A. ADMINISTRATIVE REPORT & DECISION

Project Name: Cedar Ridge Short Plat

File Number: LUA17-000263, SHPL-A

Project Summary: The applicant is requesting Preliminary Short Plat approval for a proposed six (6)-lot short subdivision. The project site is 73,417 square feet (1.68 acres) and located at 13609 156th Ave NE (APNs 146340-0045 and 146340-0049). The project site is located in the Residential-4 (R-4) zoning designation. The proposed single-family residential lots range in size from 10,634 square feet to 12,019 square feet with an overall proposed net density of 3.6 dwellings per acre. Two (2) existing single-family dwellings will be removed. Additional improvements include one (1) storm drainage tract on the west boundary of the site and curb, gutter, sidewalk and planter strip along the subject property's SE 2nd Pl and 156th Ave SE abutting frontage. The application also includes a request to modify the street standards for frontage improvements along 156th Ave SE. The proposed lots will be served by existing sanitary sewer and water mains. The applicant proposes to retain four (4) of the site's 29 significant trees resulting in a required planting of 60 new caliper inches.

PRELIMINARY
DRAINAGE PLAN

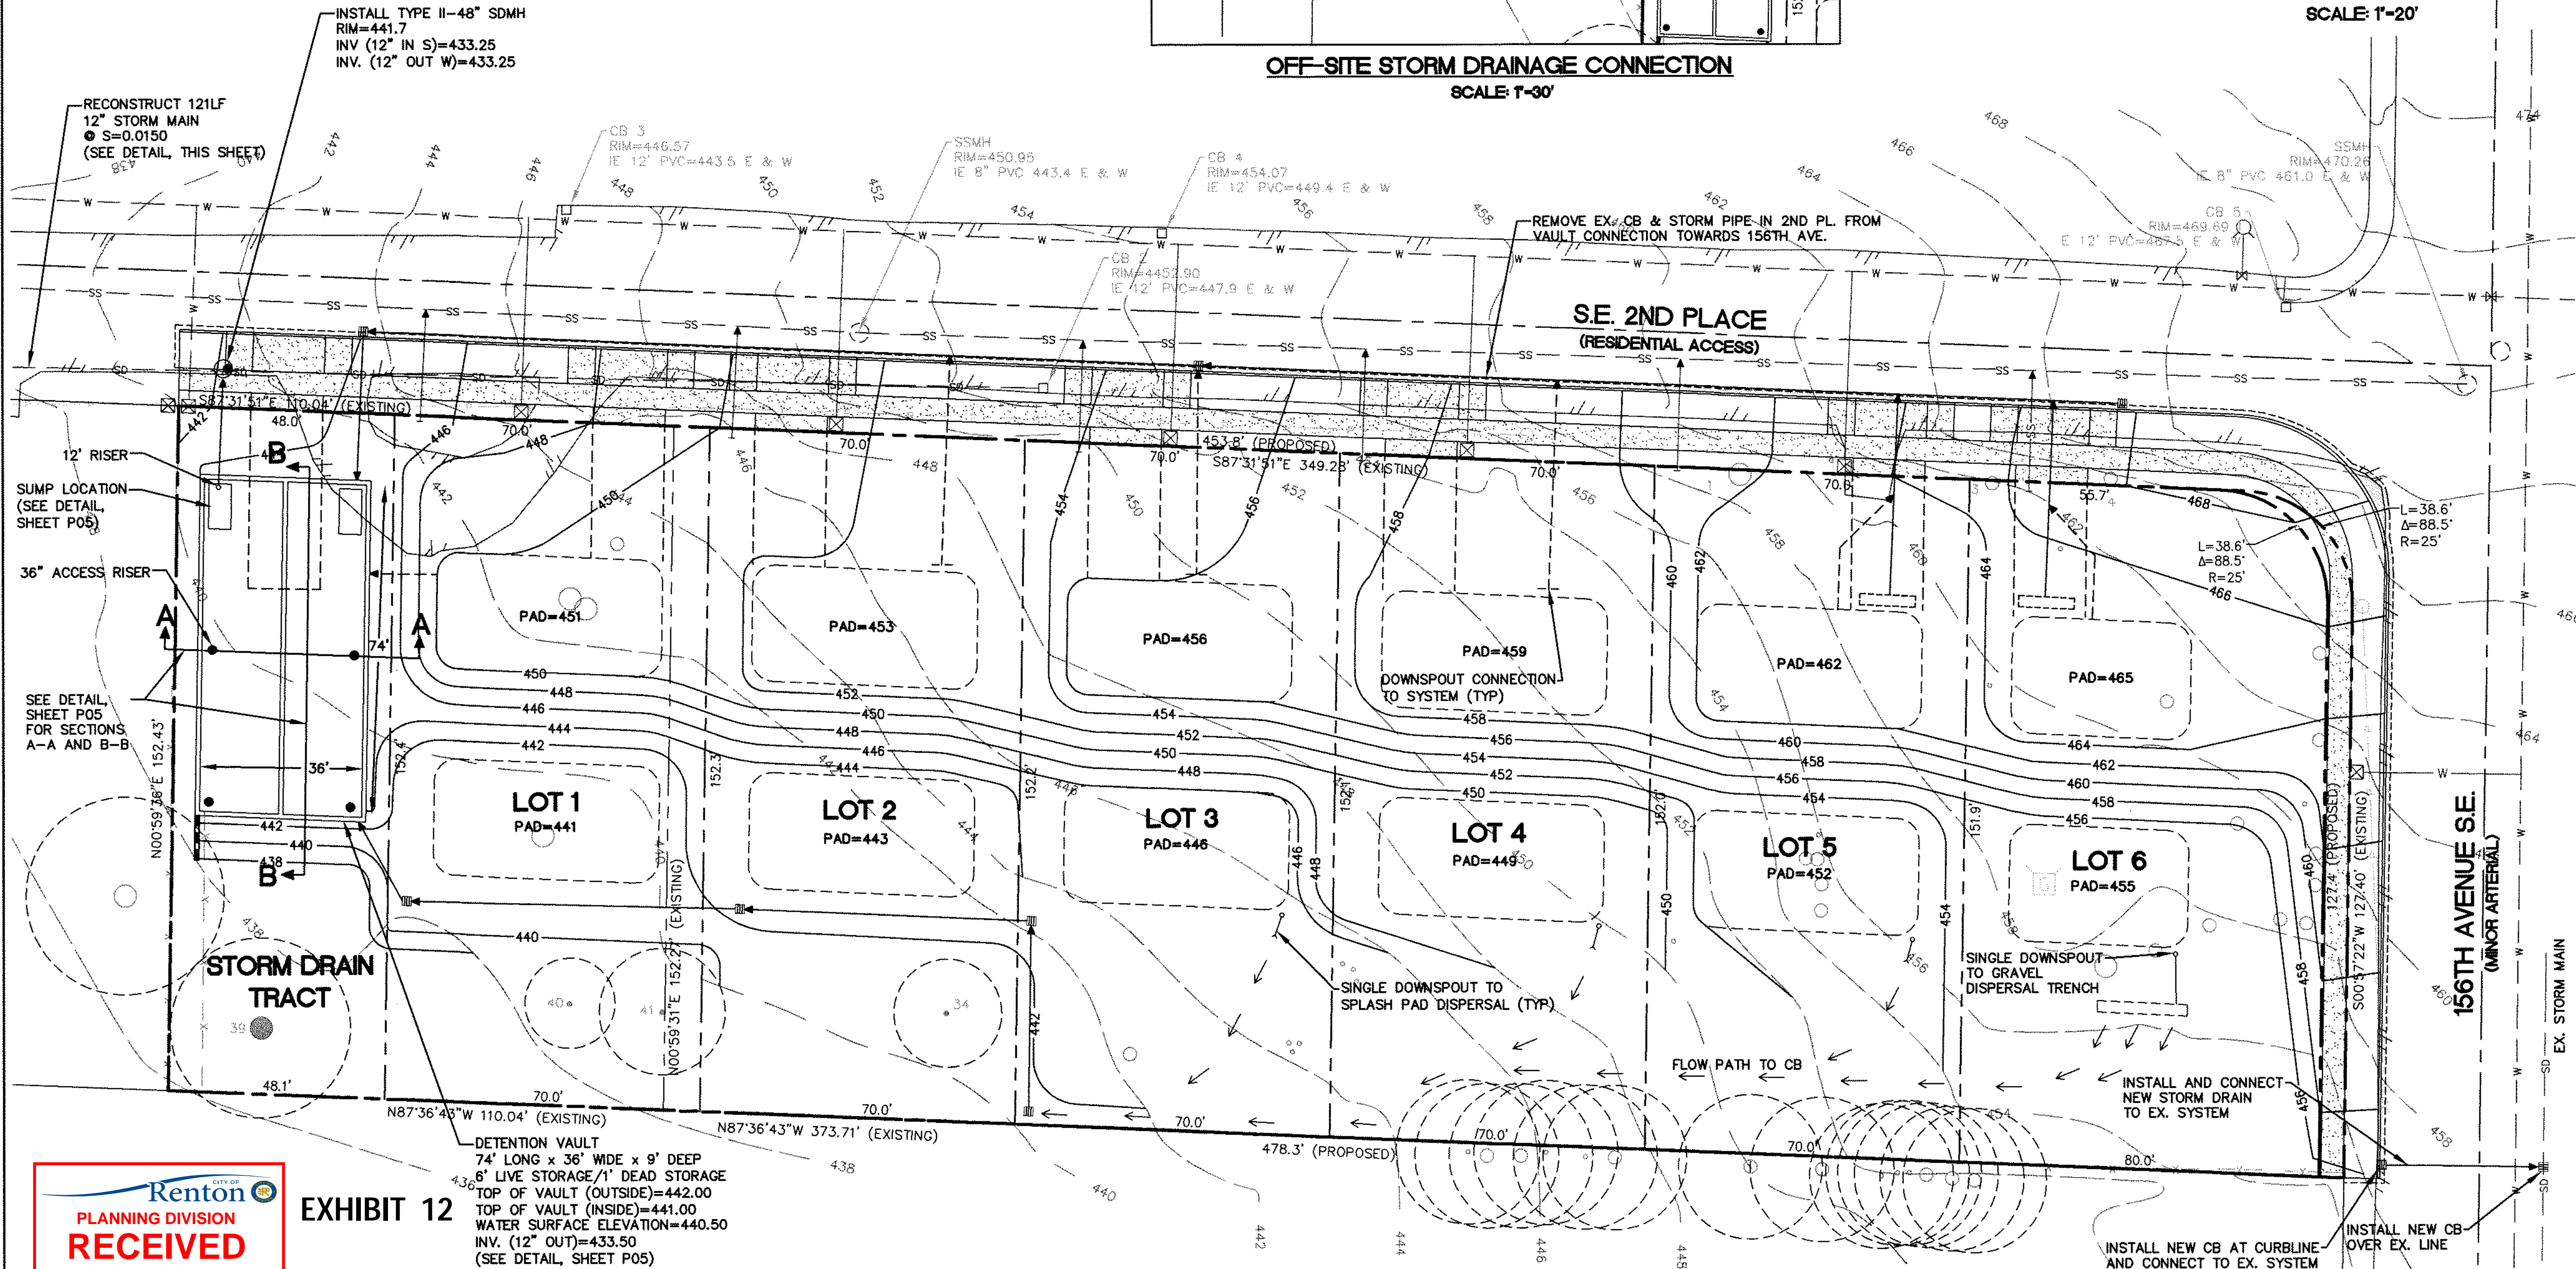
8. The applicant shall apply and receive a decision for a storm drainage adjustment to not discharge at the site's natural discharge location and instead divert the site's stormwater to another drainage basin as shown on the submitted plans. The drainage adjustment shall be submitted to the Engineering Plan

5. Per RMC 4-6-060, a curb return of 35' is required to meet City standards at the intersection of 156th Avenue SE and SE 2nd Place. The preliminary drainage plan shows a curb radius of 25'. This is not to City standards.
